Technical Review Committee

**CITY OF DELAND
THURSDAY APRIL 17, 2025 AT 1:30 P.M.
CITY OF DELAND TRC MEETING ROOM
DELAND, FLORIDA**

City of DeLand
Z24-153
NORTH HILL
VILLAS PD

Issues for record Z24-153**Job Address: 0 E CHURCH ST, DELAND FL 32724****Job Description: To rezone the property from R-1B to PD for residential townhomes**

City of DeLand
SSB25-048
DELAND AIRPORT
SUBDIVISION SKETCH

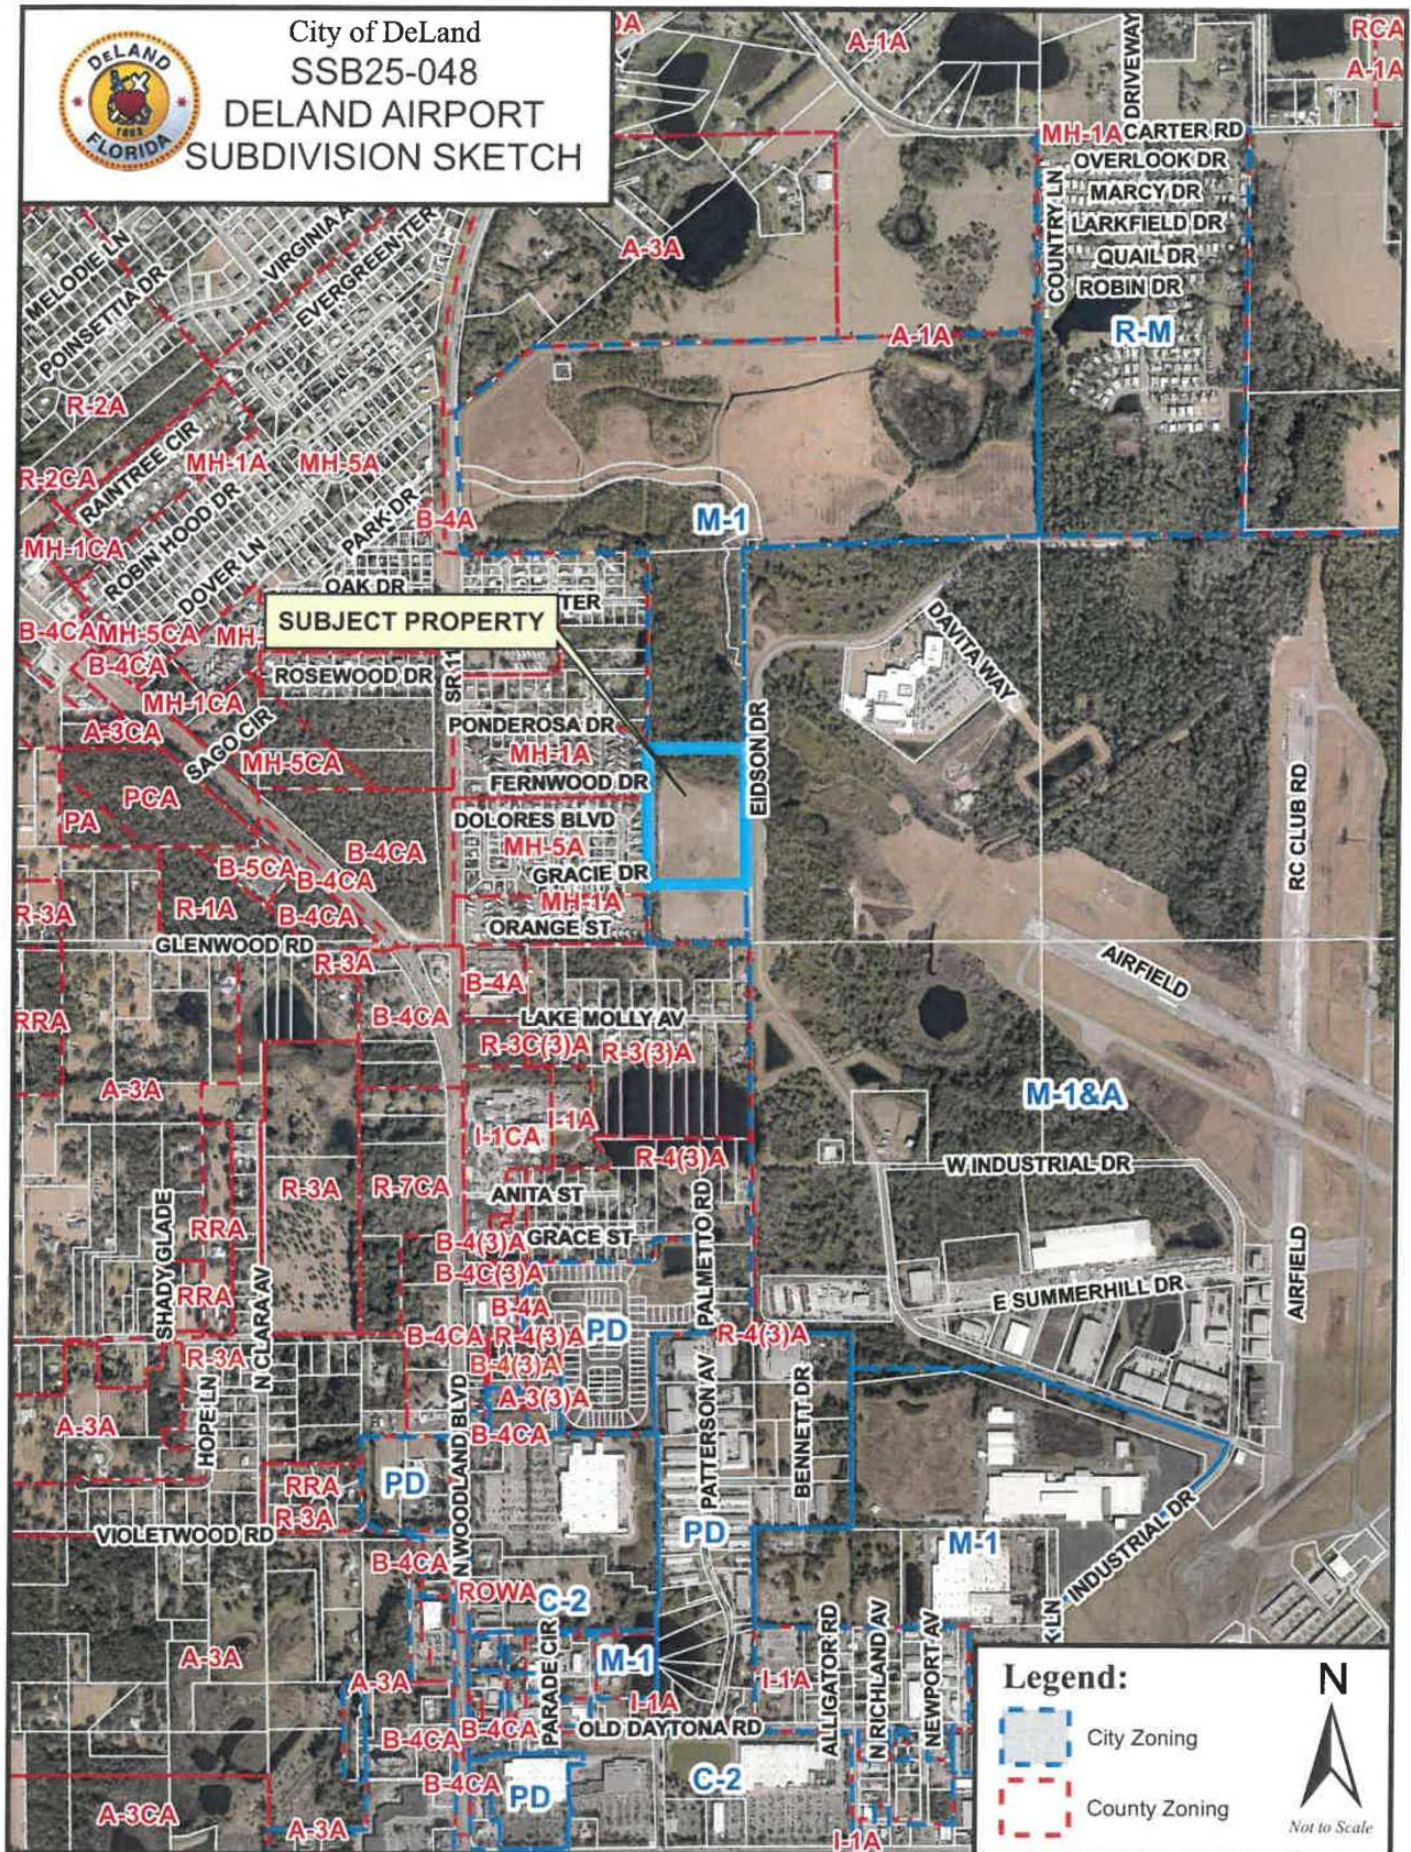
Discipline	Status	Details	Attached To	Created By	Last Updated By	Modifications Required
Forestry	Draft	Tree Preservation Tract Please change the "Tree Preservation Tract" to "Tree Protection Area Tract" to be consistent with the language in our code.	OF1	Kit Dennis	Kit Dennis	Yes
Planning	Draft	Cover sheet Provide a general cover sheet that outlines the project description, location, dedications, and a legend.	OF1	Emily Ragusa	Emily Ragusa	Yes
Planning	Draft	Sketch Plan Please note, the sketch plan is the first phase of a plat, and shall look a preliminary plat.	OF1	Emily Ragusa	Emily Ragusa	Yes
Planning	Draft	Data Table Provide a data table that outlines the purpose, ownership and maintenance of all the tracts and lots, also include the size (in acres and square footage)	OF1	Emily Ragusa	Emily Ragusa	Yes
Planning	Draft	Lot Lines The lot/tract lines need to be solid lines and any easement lines need to be dashed	OF1	Emily Ragusa	Emily Ragusa	Yes

Planning	Draft	Tracts Clearly define the tract boundary lines, make multiple tree and storm tracts if necessary.	OF1	Emily Ragusa	Emily Ragusa	Yes
Planning	Draft	Project Narrative or Letter of Intent Include a letter of intent with the Preliminary/Final plat that clearly outlines the project proposal, ensuring it meets the LDR requirements and the requirements in the Comprehensive Plan.		Emily Ragusa	Emily Ragusa	Yes
Planning	Draft	Wetlands Any activity within wetland areas will require mitigation through the SJRWMD or a 25' buffer from wetland edge will be required.		Emily Ragusa	Emily Ragusa	Yes
Planning	Draft	Burning No burning of land clearing debris is allowed within the City of Deland, and a statement shall be added to the Preliminary and Final Plat.		Emily Ragusa	Emily Ragusa	Yes
Planning	Draft	Zoning Include the zoning classification of each lot	OF1	Emily Ragusa	Emily Ragusa	Yes

Discipline		Status	Details		Attached To	Created By	Last Updated By	Modifications Required
Planning	Draft	ROW	Include the dimensions of existing and proposed right-of-ways		OF1	Emily Ragusa	Emily Ragusa	Yes
Planning	Draft	Advisory Comments for Preliminary Plat Please refer to Section 33-146.03 for Preliminary Plat requirements.			OF1	Emily Ragusa	Emily Ragusa	Yes
